HISTORIC AND DESIGN REVIEW COMMISSION

September 05, 2018

HDRC CASE NO: 2018-408
ADDRESS: 320 E COURTLAND PLACE
LEGAL DESCRIPTION: NCB 2999 BLK 1 LOT 11 AND 12
ZONING: R-6 H
CITY COUNCIL DIST.: 1
DISTRICT: Tobin Hill Historic District
APPLICANT: Ryan Shramek
OWNER: Laura Barnes
TYPE OF WORK: Installation of handrails on front and side porches
APPLICATION RECEIVED: August 09, 2018
60-DAY REVIEW:
REQUEST:

Proposed changes (Site Plan/Floor Plan)

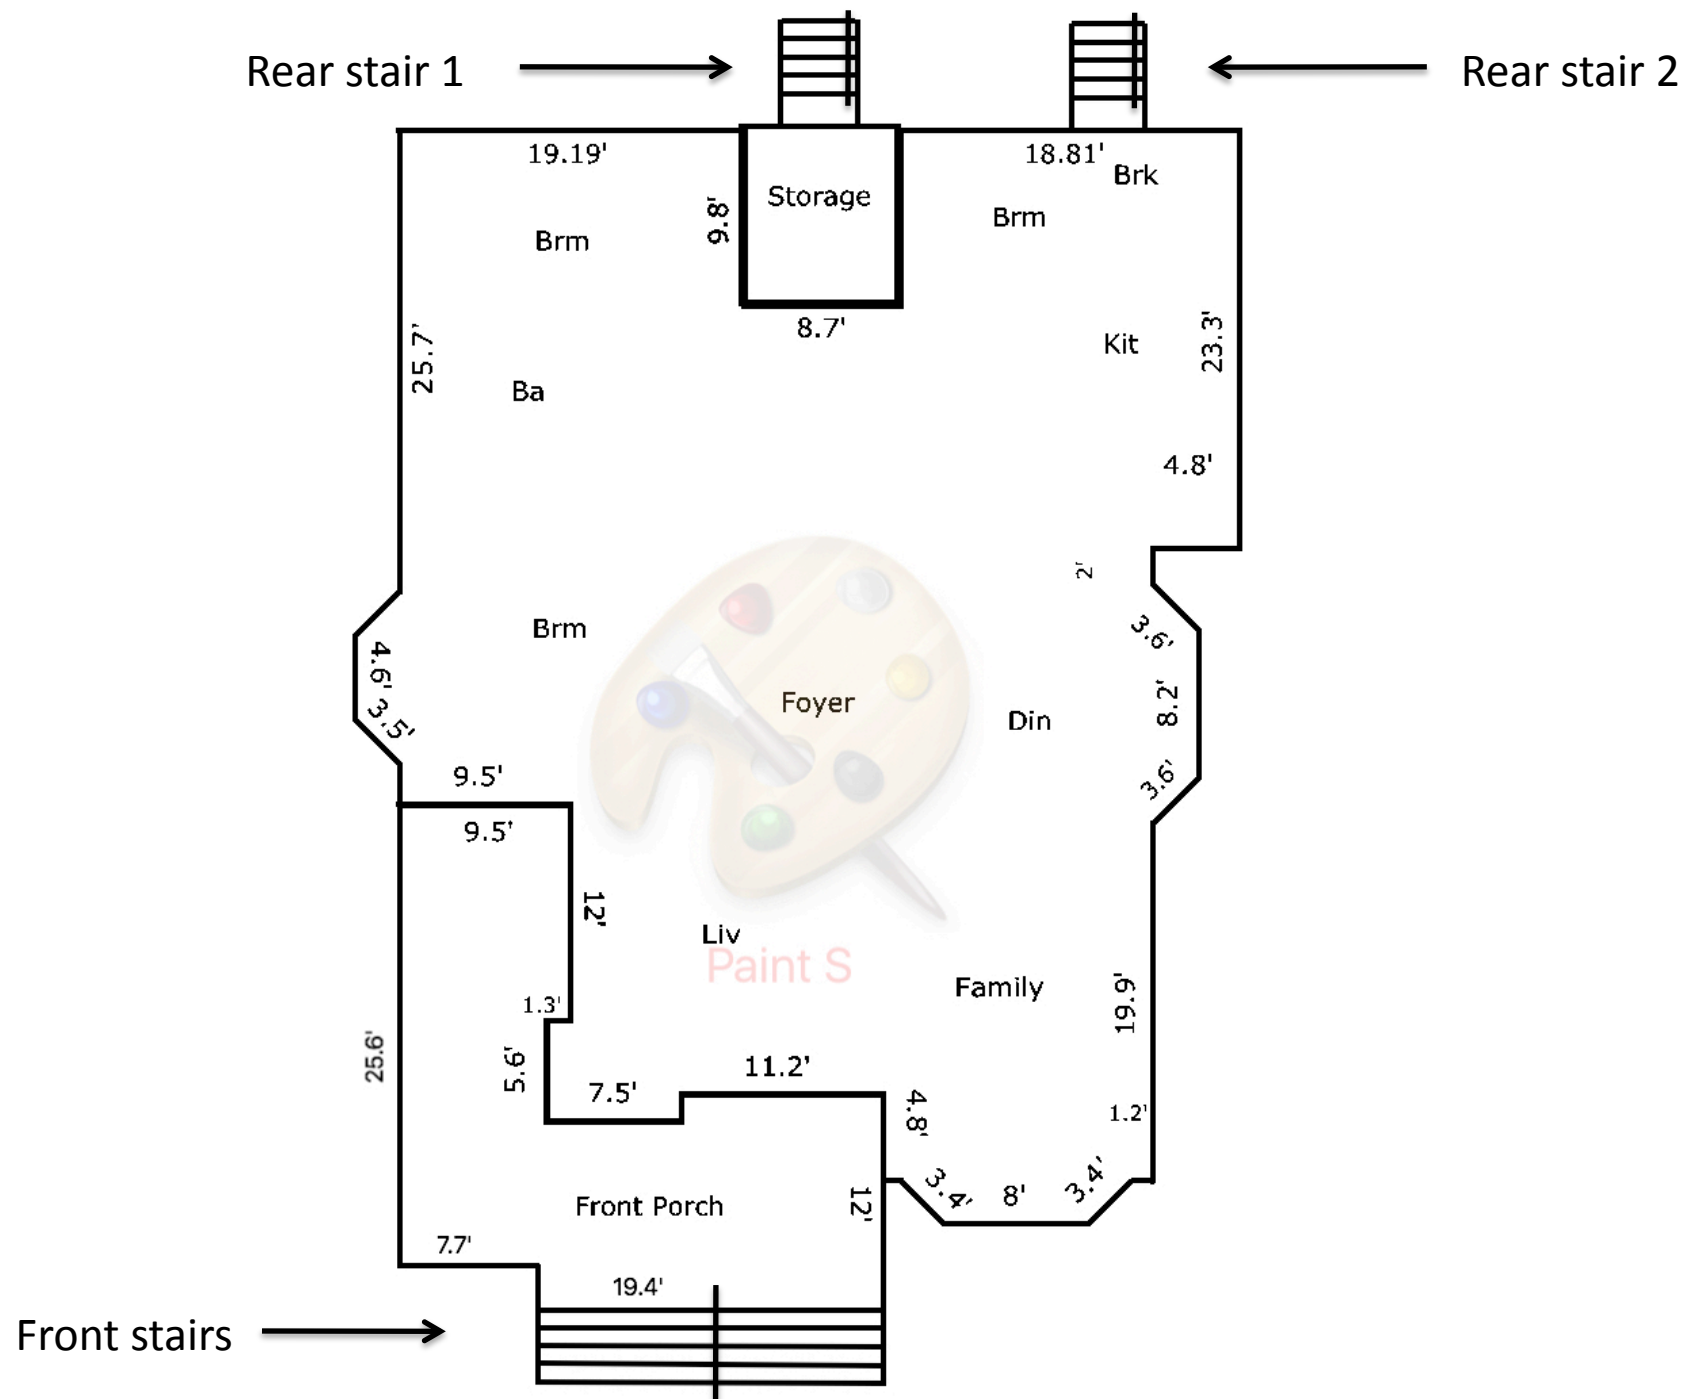
We are proposing adding three exterior handrails. There are three exterior entrances with more than four stairs, one in the front and two in the rear of the house. Building code requires a railing when more than four risers are present. We are proposing using the same design for all three railings, with the two in the rear being identical. We propose using 1.5" galvanized steel pipe with a height of 36". The posts and handrail will both be 1.5" galvanized steel pipe. We will secure the railing into the concrete with concrete screws. We would like to paint the railing black. We propose having a single railing at each site. The railing at the front of the house will run in the middle since the stairs are wide. The railings in the rear of the house will run along the left side. The inspiration for this design came from a similar house (photos attached), and we plan to replicate their design.

Staff recommends approval based on findings a and b.

Rear Stairs

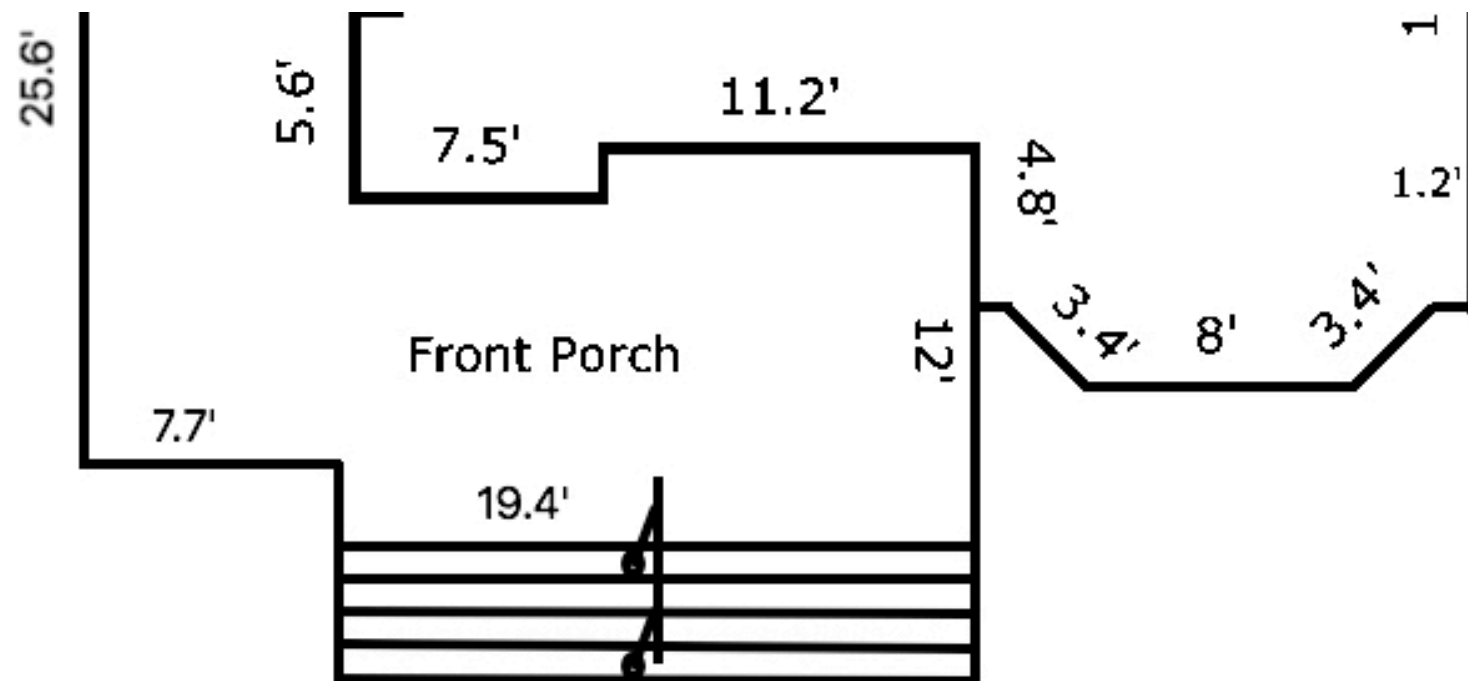
There are currently three exterior sets of stairs that have more than four risers but no handrail. By building code, these stairs should have at least one handrail. We plan to add one handrail to each set of stairs. Each handrail will be made of 1.5 inch galvanized metal pipe. Each handrail will be 36 inches from the ground and anchored by two posts, one at the top stair and one at the bottom stair. The handrails will be painted black. The handrails associated with the stairs at the rear of the house will be on the left side of the stairs. The handrail with the front stairs will be in the middle of the stairs because these stairs are very wide.

Proposed handrail design

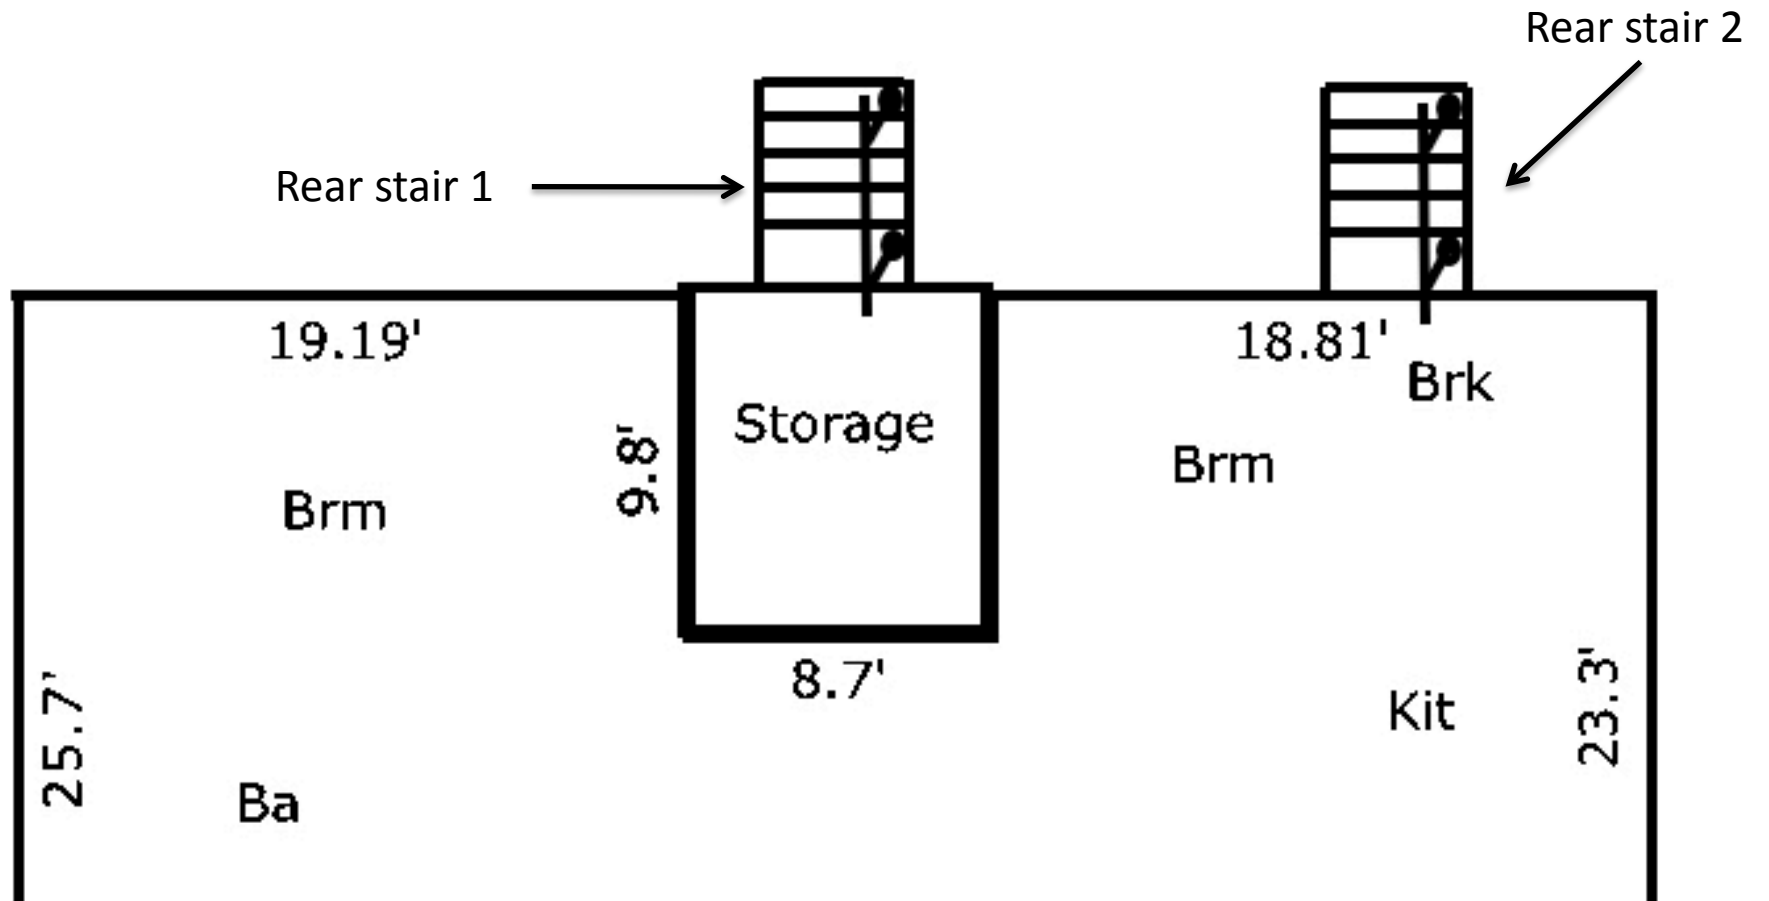
be made of 1.5 inch galvanized metal pipe. Each handrail will be 36 inches from the ground and anchored by two posts, one at the top stair and one at the bottom stair. The handrails will be painted black. The handrails associated with the stairs at the rear of the house will be on the left side of the stairs. The handrail with the front stairs will be in the middle of the stairs because these stairs are very wide. According to the Historic Design Guidelines, new balusters should match the original in terms of materials, spacing, profile, dimension, finish, and height of the railing. If no such evidence exists, new elements should be simple so as to not distract from the historic character of the building and should not create a false sense of historic appearance. The proposed railings are simple in design, will not detract from the significance of the building, and are fully reversible. Staff finds the proposal acceptable based on these considerations.
